March 5, 2019

ADDENDUM #1
Remodeling of the
Baldwin Emergency & Facilities Management Complex
240 Baldwin Drive Lancaster, Ohio 43130

In accordance with the Construction Documents for the above named Project, this ADDENDUM #1, consisting of pages 1 and 2, and attachments A0.2, P2.1, P3.1, is hereby made a part of the Construction Documents as if written therein.

SITE
LAYOUT
PLAN
DRAWING NUMBER
A0.2

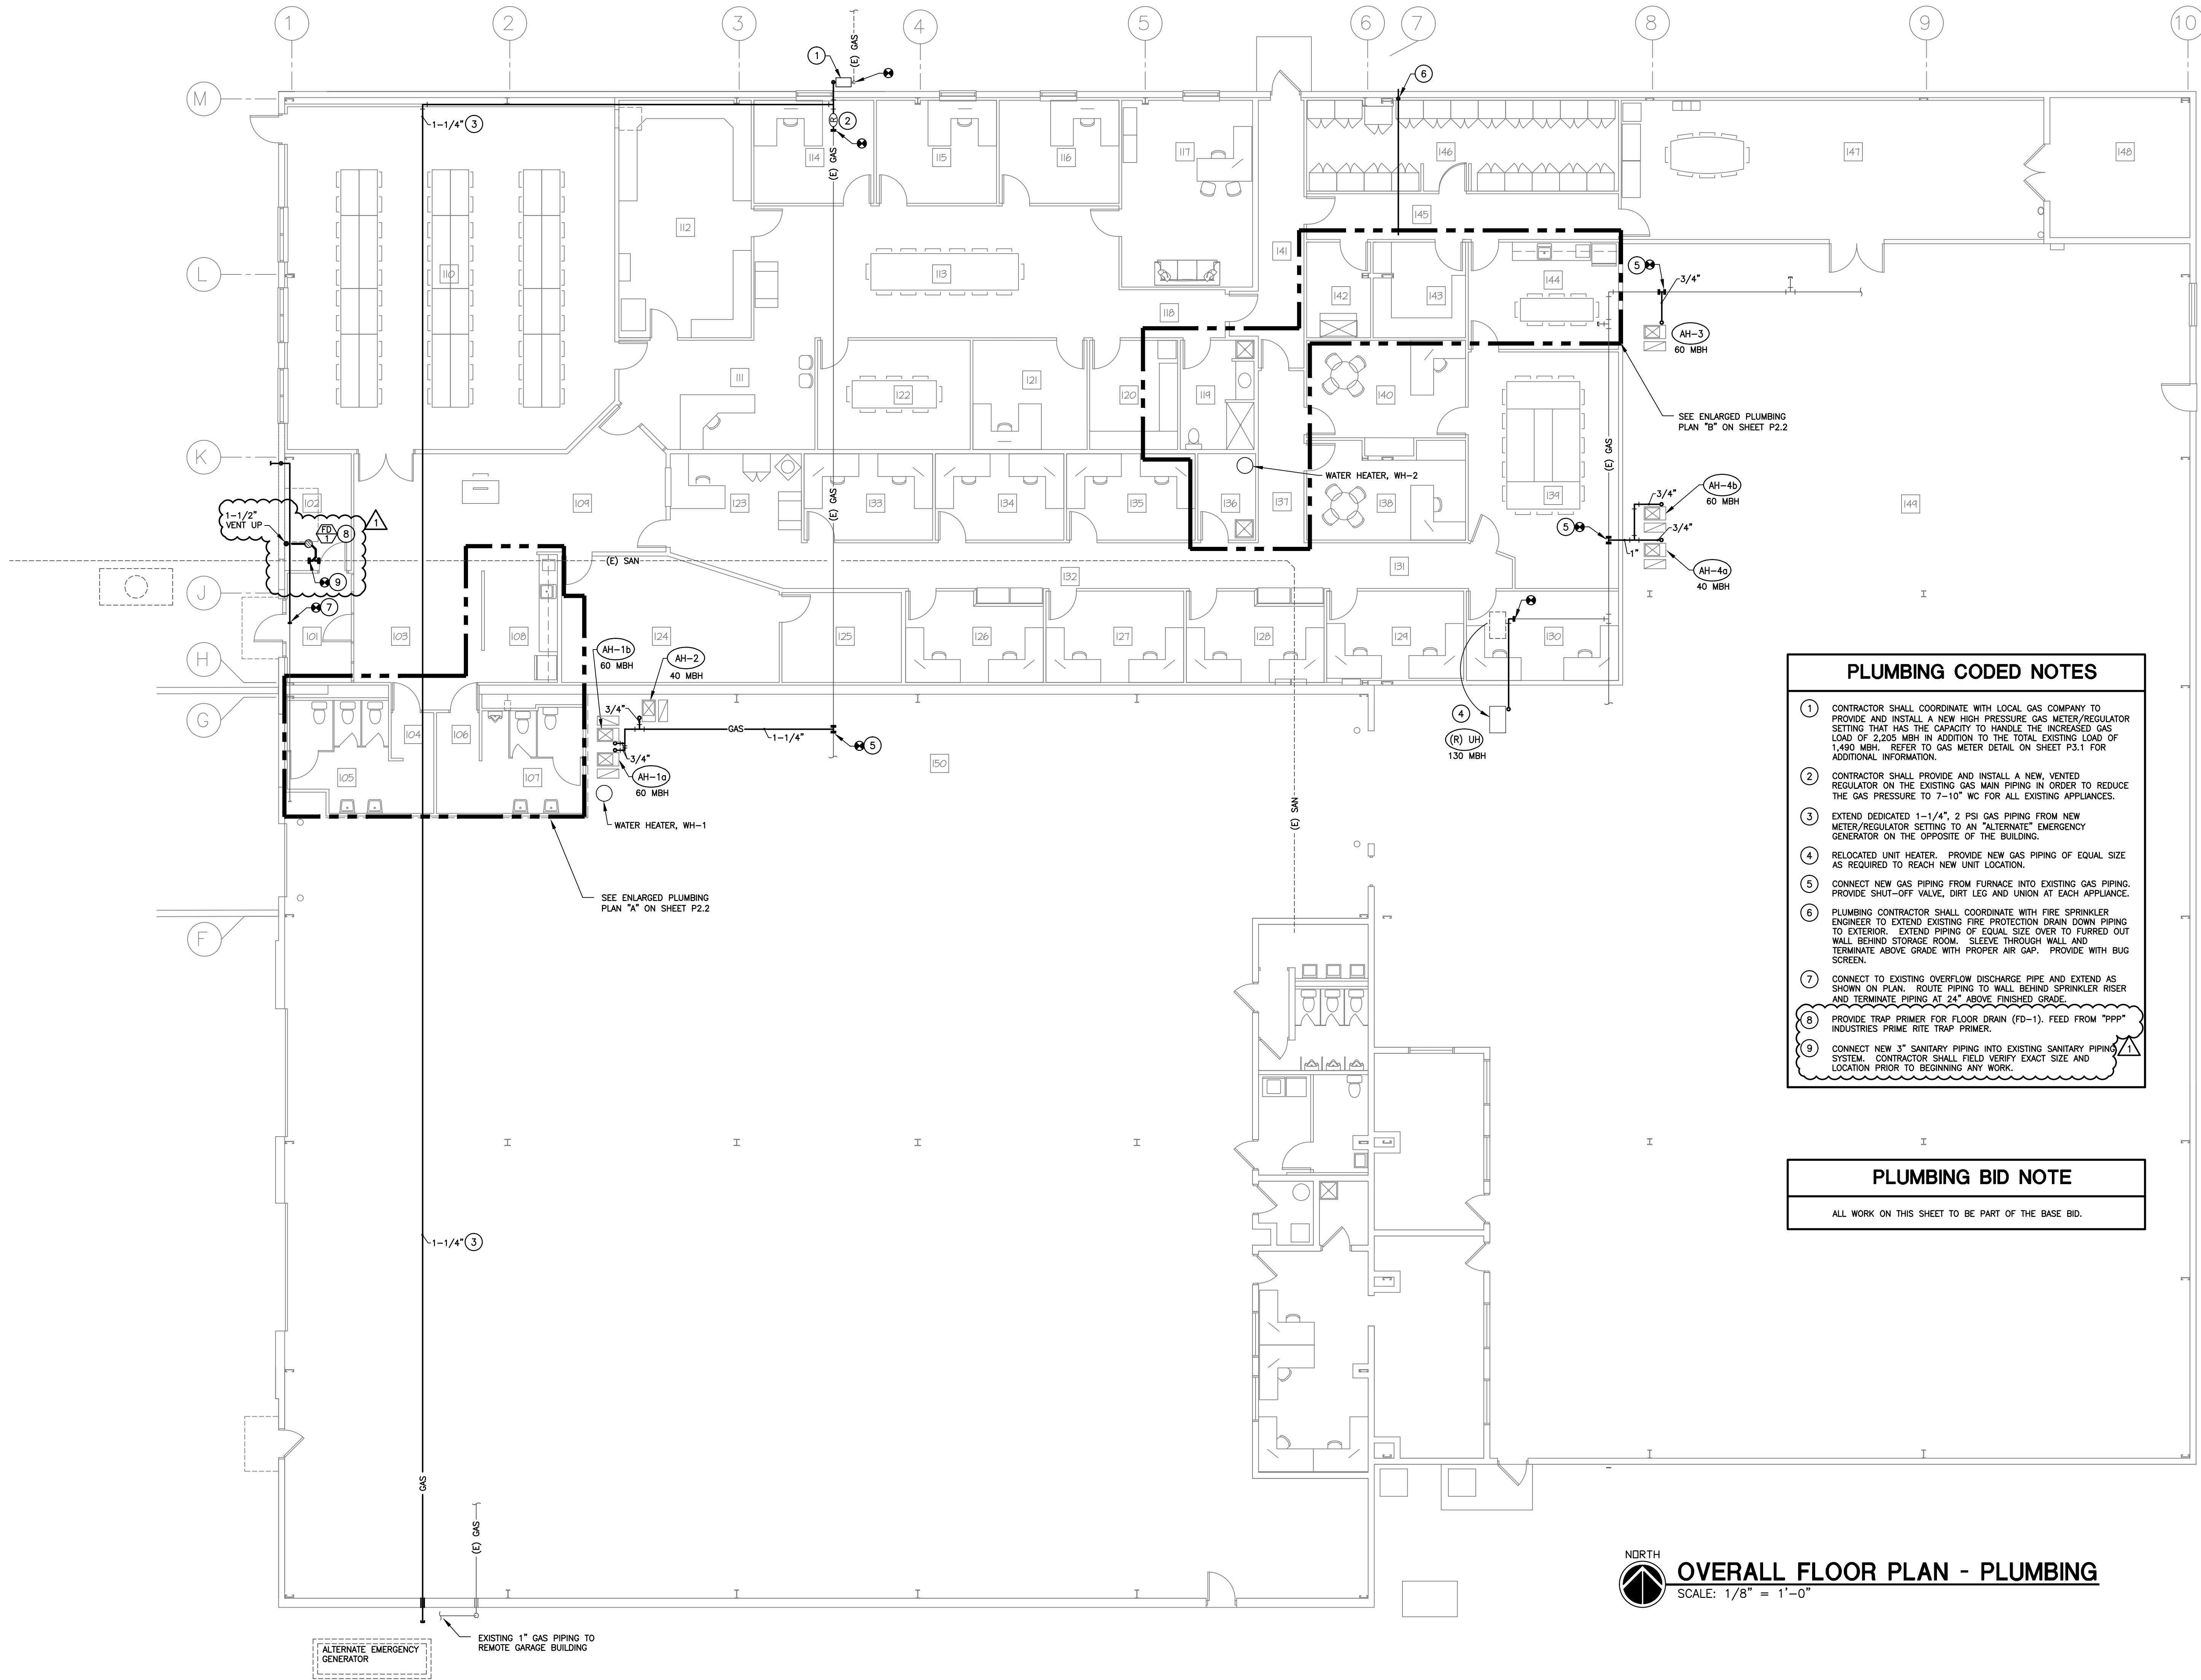
- Item 2. **Sheet A0.2 SITE LAYOUT PLAN**
- a. Add two pole mounted handicapped parking signs in the parking lot as shown on attached revised sheet A0.2.
 - b. Contractor is to provide temporary construction fencing around the existing asphalt lot adjacent to the west façade of the existing building where shown bounded by the heavy dashed line.
- Item 3. **Sheet A2.1 FLOOR PLAN / ROOM FINISH AND DOOR SCHEDULES**
- a. In the 'Notes' column of the Door Schedule, remove note #2 at door 101a.
 - b. Modify the first sentence in coded note #11 to be: "Sanitary napkin dispensers, toilet paper holders, soap dispensers and paper towel dispensers by Owner."
 - c. Add to coded note #23: "Knox Box to be wall mounted, ABS plastic coated, metal framed, waterproof vault with case, with key pad concealed behind hinged cover plate. Key Guard #SL-590 or approved equal by Kidde or Master Lock.

DRAWING NUMBER
P2.1

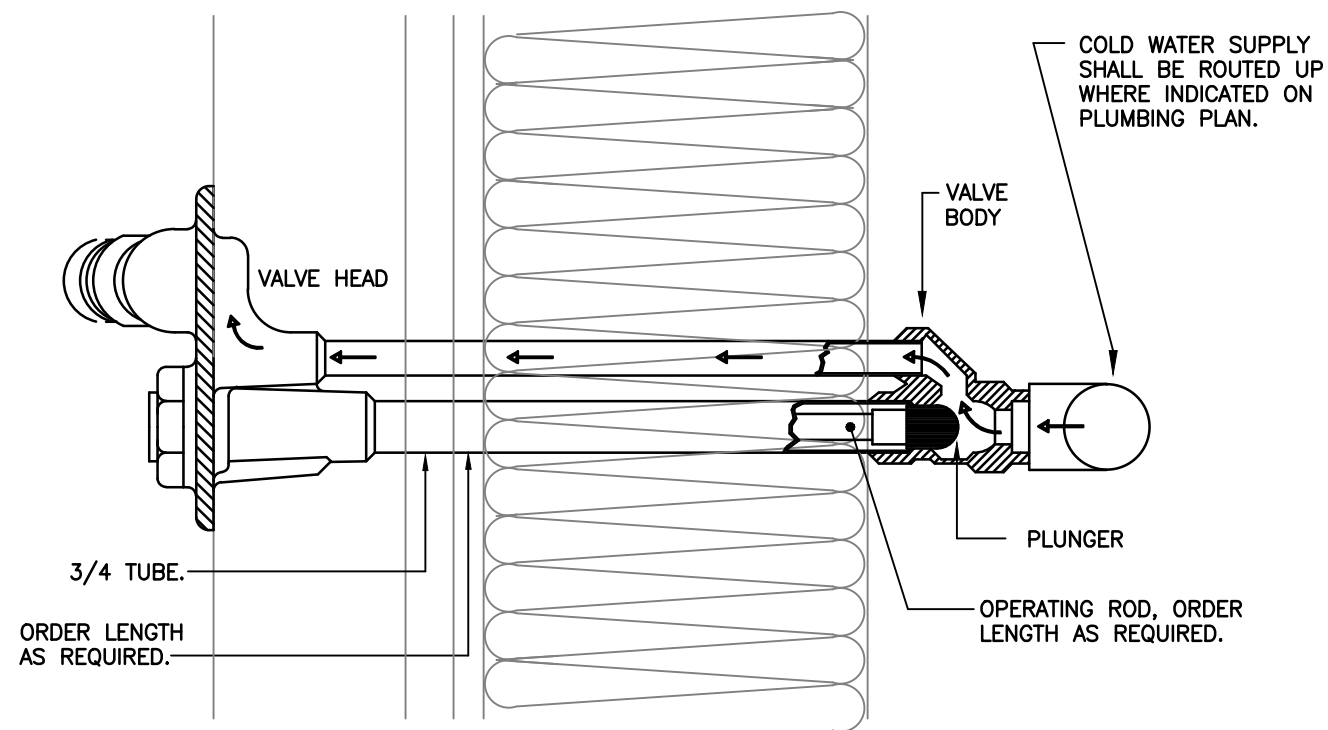
- Item 5. **Sheets P2.1 PLUMBING FLOOR PLAN and P3.1 PLUMBING FLOOR PLAN**
a. Add new floor drain adjacent to existing sprinkler riser as shown on the attached revised sheets P2.1 and P3.1. Saw cut and patch existing concrete slab as required for associated pipe trenching to tie into existing sanitary drain pipe.
